<b>Docket Number:</b>	21-IEPR-05
<b>Project Title:</b>	Natural Gas Outlook and Assessments
<b>TN #:</b>	239691
<b>Document Title:</b>	SEIA Comments to the CEC on August 30 2021 IEPR Natural Gas Workshop
<b>Description:</b>	N/A
<b>Filer:</b>	Chester Hong
<b>Organization:</b>	SEIA/Patrick McGuire
<b>Submitter Role:</b>	Public
<b>Submission Date:</b>	9/14/2021 9:13:24 AM
<b>Docketed Date:</b>	9/14/2021

### **Comments on the August 30, 2021, *IEPR Commissioner Workshop on Natural Gas Market and Demand Forecasts***

Figure 1

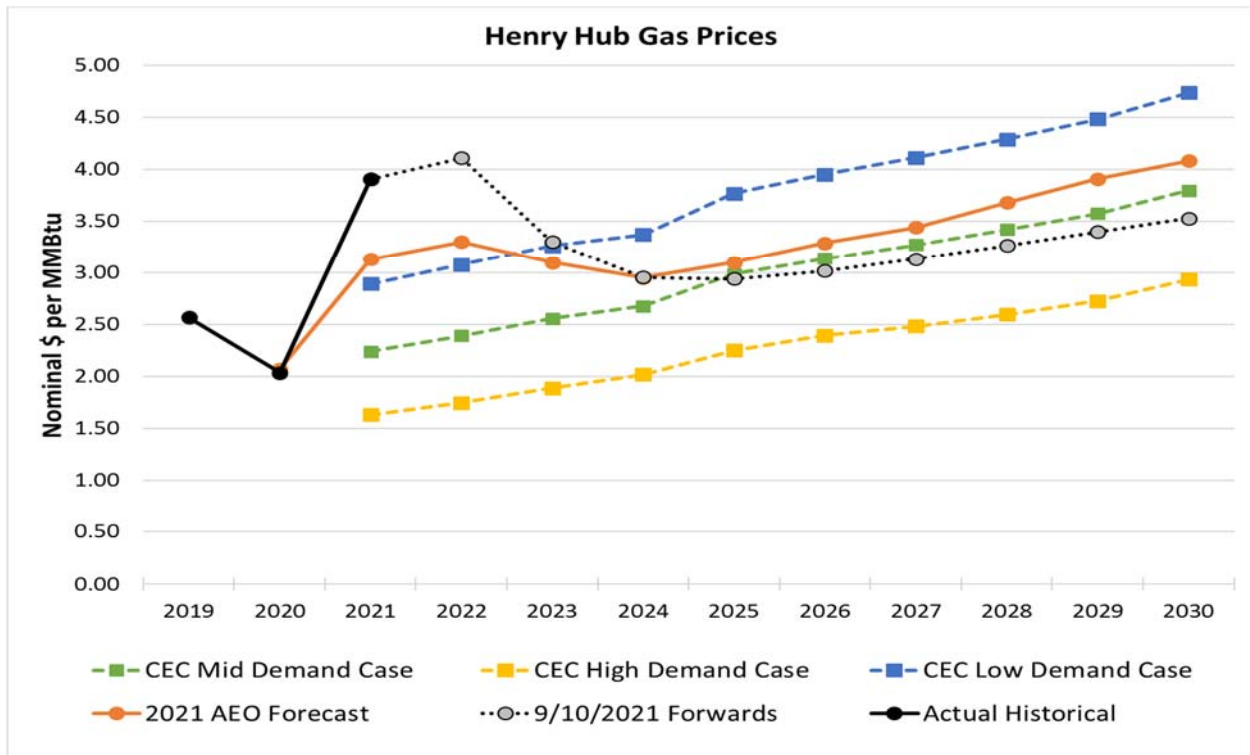
Gas commodity prices at the benchmark Henry Hub were low in 2020 as a result of reduced demand as the economy faltered from the Covid-19 pandemic. But prices have rebounded sharply in 2021 as the economy has improved and as the result of supply disruptions from the Texas cold snap in February 2021 and, more recently, Hurricane Ida on the Gulf Coast. Henry Hub prices are on track to average about \$4.00 per MMBtu in 2021, about double the level of 2020. The forward market and other forecasts such as the Energy Information Administration’s 2021 *Annual Energy Outlook* also show significantly higher forecasts for natural gas commodity prices in 2022 and 2023, as illustrated in **Figure 1** below. SEIA recommends that the CEC should recognize that its IEPR forecast is based on analysis at a specific point in time, and that near-term prices in particular can and will change quickly. As a result, the Commission should encourage the use of other projections, including the deeply-traded initial two years of the gas forward market, for projecting near-term prices over the next two years.

**Figure 1:** PG&E Schedule G-EG Rates (\$/MMBtu)

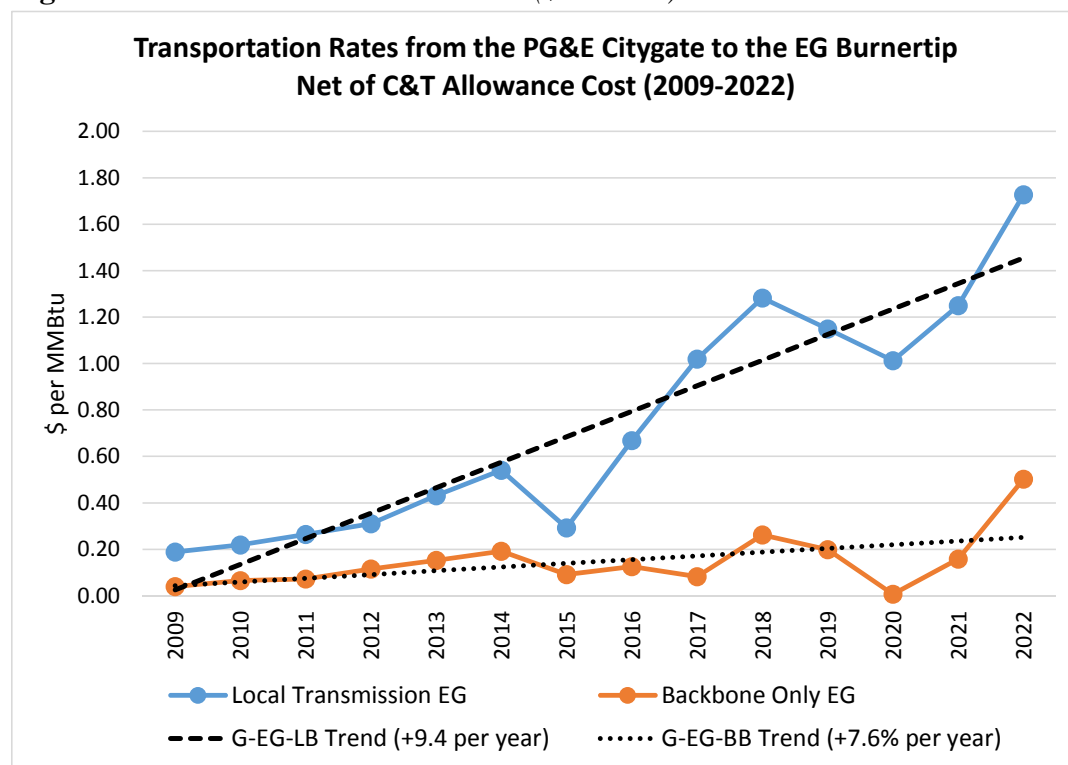
The rates in **Figure 1** below show the cost (net of the GHG fees paid by generators directly to ARB) for intrastate transportation on the PG&E system from 2009 to 2022 for local T EG plants (blue line) and backbone-level EG plants (orange line), assuming the gas commodity was purchased at the PG&E Citygate. The figure shows that PG&E G-EG rates grew during the period at +7.6% and +9.4% per year, for G-EG LT and G-EG BB customers, respectively.

**Figure 2:** *PG&E Backbone Annual Firm On-system Rates (\$/MMBtu)*

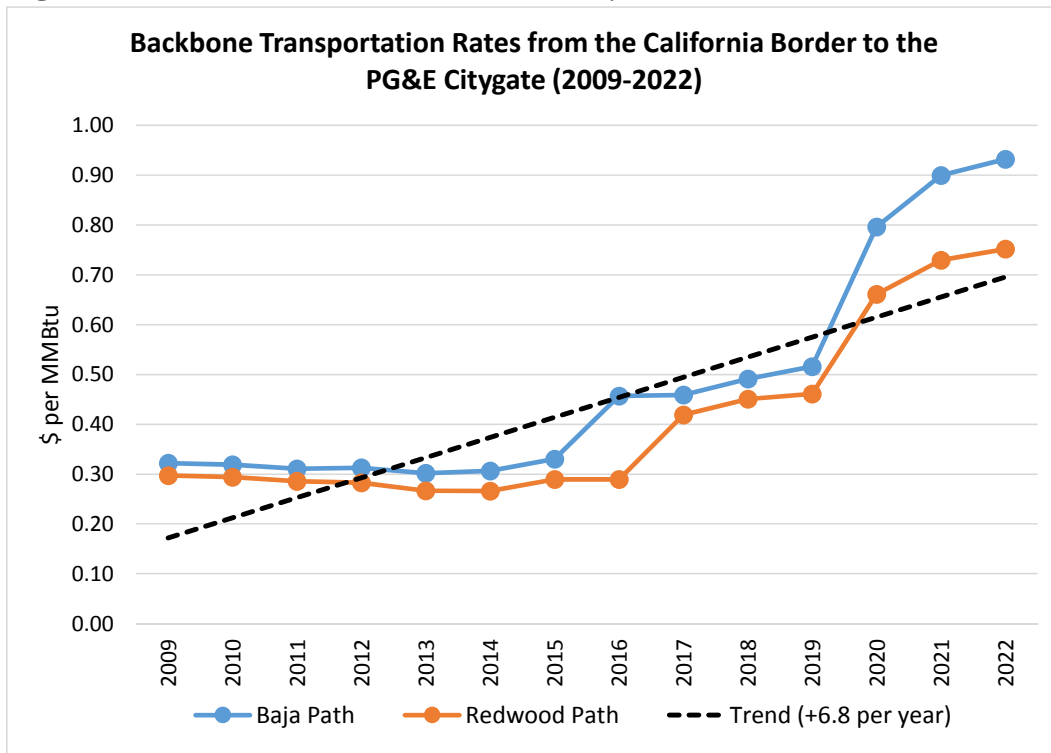
**Figure 2**, below, indicates the additional intrastate transportation costs (excluding shrinkage) that would apply if gas is purchased at the California border and transported to the PG&E City-gate. These rates are adopted in PG&E’s Gas Transmission and Storage (GT&S) rate cases. Baja Path (for transportation from Topock to the PG&E City-gate) and Redwood Path (for transportation from Malin to the PG&E City-gate) backbone rates have increased from 2009 to 2022 at +6.8% per year (using the firm annual rates and assuming a 100% load factor). The average backbone rates in 2021 were about \$0.73 per MMBtu and \$0.90 per MMBtu, on the Redwood and Baja paths, respectively.

**Figure 2:** Slide 22 from the E3 Gas Study

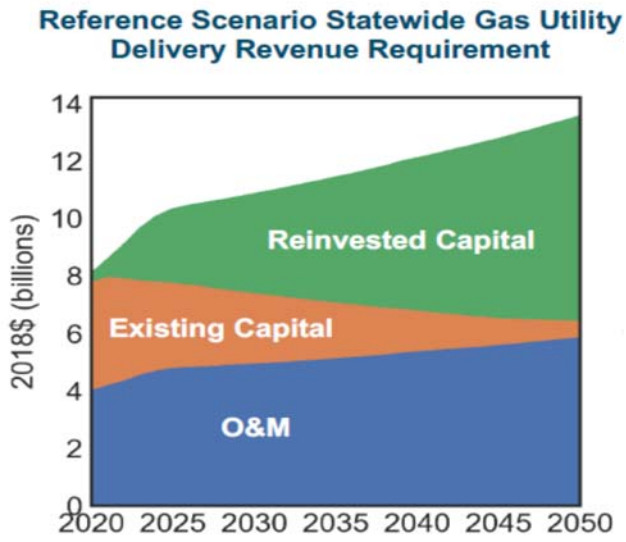
E3's study projects continued sharp increases in the revenue requirements for the gas utilities of 5% real per year (i.e. 5% above inflation) through 2025, due to continuing safety-related investments, then increasing at 1% real thereafter through 2050. See **Figure 2** below, which is Slide 22 from the E3 Gas Study. At the same time, in the favored high building electrification case, overall throughput on the gas system declines at about 3.5% per year from 2020-2050, with EG throughput dropping at 5% per year in all scenarios. See **Figure 3**, which is Slide 16 from the E3 Gas Study.

**Figure 3:** Slide 16 from the E3 Gas Study

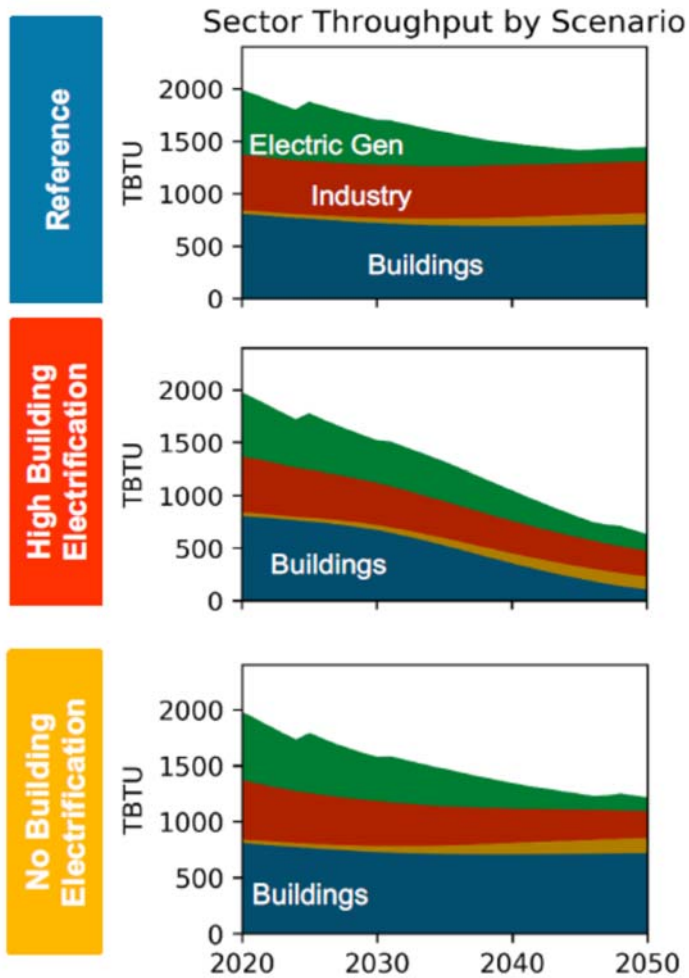
Assuming that EG customers' share of the overall revenue requirement changes in proportion to their share of the overall throughput, the E3 results suggest a long-term real escalation in EG rates in excess of 10% per year through 2025 (continuing the trend since at least 2010) and 5% to 10% per year after 2025, unless steps are taken to reduce future gas system revenue requirements. The E3 study suggests a number of steps that could be taken (but have yet to be adopted) to mitigate future rate increases, including the accelerated depreciation or targeted retirement of gas assets.
